# UNITED STATES PATENT AND TRADEMARK OFFICE

APPLICATION NO.	FILING DATE	FIRST NAMED INVENTOR	ATTORNEY DOCKET NO.	CONFIRMATION NO.
10/733,906	12/11/2003	Alexandr Pekar	RFSUNY-3672	8482
41672	7590	03/22/2005	EXAMINER	
SANDER RABIN MD JD CONVERGENT TECHNOLOGY PATENT LAW GROUP 2 IRVING PLACE TROY, NY 12180-4417			WIEKER, AMANDA FLYNN	
			ART UNIT	PAPER NUMBER
			3743

<b>Office Action Summary</b>	<b>Application No.</b> 10/733,906	<b>Applicant(s)</b> PEKAR, ALEXANDR	
	<b>Examiner</b> Amanda F. Wieker	<b>Art Unit</b> 3743

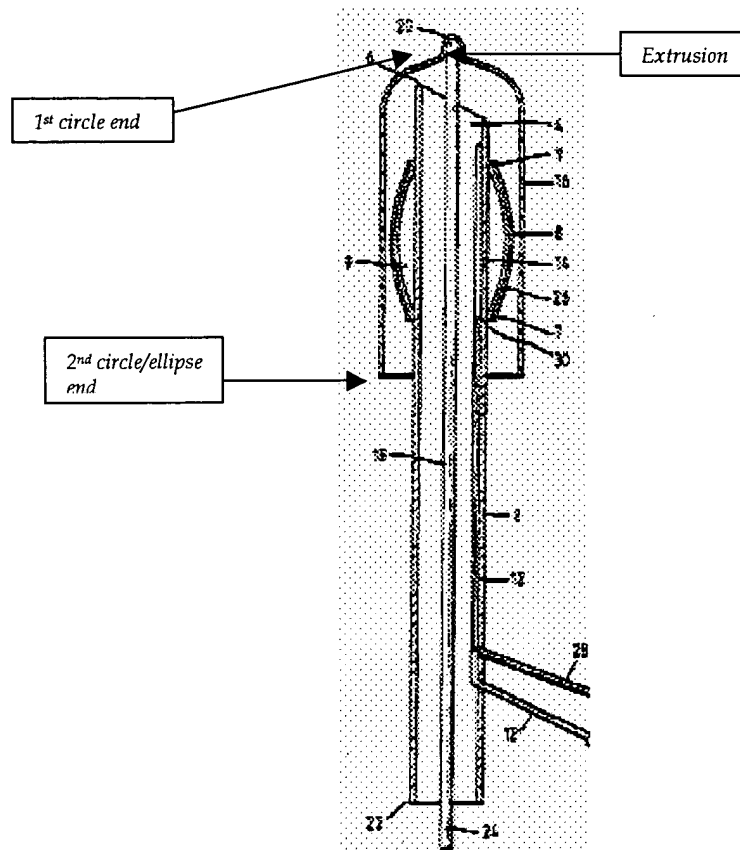
Perry discloses the previously described introducer for removable disposition within an endotracheal tube, wherein the introducer has a tubular member and a shroud. Perry shows that the shroud of the introducer has a substantially frusto-conical shape extending from a first circle (noted below), in a first plane perpendicular to a longitudinal axis of said introducer, to a second circle (noted below) in a second plane parallel to said first plane, said second circle of said shroud being generally coaxial with said introducer and unattached to said introducer. Perry shows the first circle being invertibly attached to the introducer at an extrusion on the tubular member of the introducer such that the shroud can flex forward and rearward with respect to the connection, said connection forming a circumferential pivot point. Perry does not specify that the first circle coincide with a "ring" of the introducer.

However, Applicant does not disclose any significant criticality to the presence of a ring at the connection to the first circle, over a connection at an extrusion. Applicant's instant specification further allows that instead of a ring, the first circle may be connected to the introducer at an extrusion of the tubular member of the introducer.

It would have been obvious to one skilled in the art at the time the invention was made to have provided the introducer as taught by Perry, wherein the first circle of the shroud is invertibly attached to either an extrusion on the introducer, or to a ring, to securely connect the shroud to the introducer, such that the shroud can flex forward and rearward with respect to the connection.
